Access Compliance Report

Public Rights-of-Way

(Curb Ramps)

Intersection ID: 10039485	Main Street: TELEVISION_PL	Cross Street: N/A	Location: SE
ADA ID: F569D879E404	Ramp Type: PerpDiag	Initial Pass/Fail: Fail	Overall Compliance: No
Codes/Mitigation Info/Possible Solution		Field Measurements/Component Compliance	
Severity Score: 50

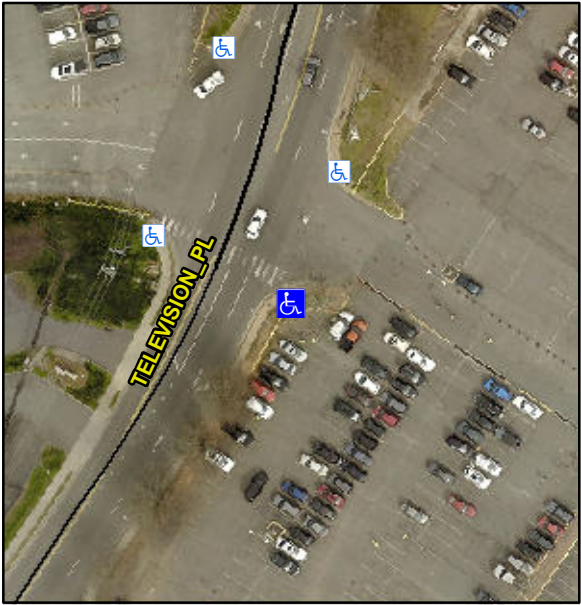
Possible Solutions:	Compliance	Description	Data	Compliance	Description	Data
	Remove & Replace Curb Ramp With Two New Directional Ramps or Equivalent.	N/A	Ramp Length (in)	48.0	No	Ramp Slope (%)	14.1
		Yes	Ramp Width (in)	48.0	No	Ramp XSlope (%)	11.2
		N/A	Flare Type LT	N/A	N/A	Flare Type RT	N/A
		N/A	Flare Slope LT (%)	N/A	N/A	Flare Slope RT (%)	N/A
		N/A	Flare Traversable LT?	N/A	N/A	Flare Traversable RT?	N/A
		N/A	Landing Length (in)	N/A	N/A	DWS Provided?	N/A
		N/A	Landing Width (in)	N/A	N/A	DWS Contrast?	N/A
		N/A	Landing Slope (%)	N/A	N/A	DWS Length (in)	N/A
		N/A	Landing X Slope (%)	N/A	N/A	DWS Full Width?	N/A
<p>Surveyor Notes:</p> <p>N/A</p> <p>PROW/ADA:</p> <p>Not Found, R304.2.2, R304.5.3</p>		N/A	Landing Curb? (Y/N)	N/A	N/A	DWS Offset (in)	N/A
		N/A	Shared Landing?	N/A			
		N/A	Gutter Ponding?	N/A	N/A	Gutter Slope (%)	N/A
		N/A	Gutter Lip Ht (in)	N/A	N/A	Gutter X Slope (%)	N/A
		N/A	Painted X Walk1?	No	N/A	Painted X Walk2?	Yes

X Walk 1 Direction	To NE		X Walk 2 Direction	To NW
		N/A	X Walk 1 Width (in)	N/A	N/A	X Walk 2 Width (in)	123.0
			X Walk 1 Slope (%)	4.6		X Walk 2 Slope (%)	4.2
			X Walk 1 X Slope (%)	6.9		X Walk 2 X Slope (%)	5.9
		N/A	Ramp inside XWalk1?	N/A	N/A	Ramp inside XWalk2?	Yes
<p>Street 1 Name</p> <p>Stop Condition-Street 2</p> <p>Street 2 Name</p> <p>Stop Condition-Street 1</p>			Road Slope (%)	9.3	N/A	Clear Space?	N/A
			Road X Slope (%)	1.8	N/A	Clear Space to XWalk (in)	N/A
		N/A	Any Obstructions?	N/A	N/A	Storm Grate/Utility Hazard?	N/A
			Obstruction Type			Storm Grate/Utility Type	
					N/A		N/A
					Yes	Surface Condition? (G/P)	Good
Total Cost:		\$	3200.00
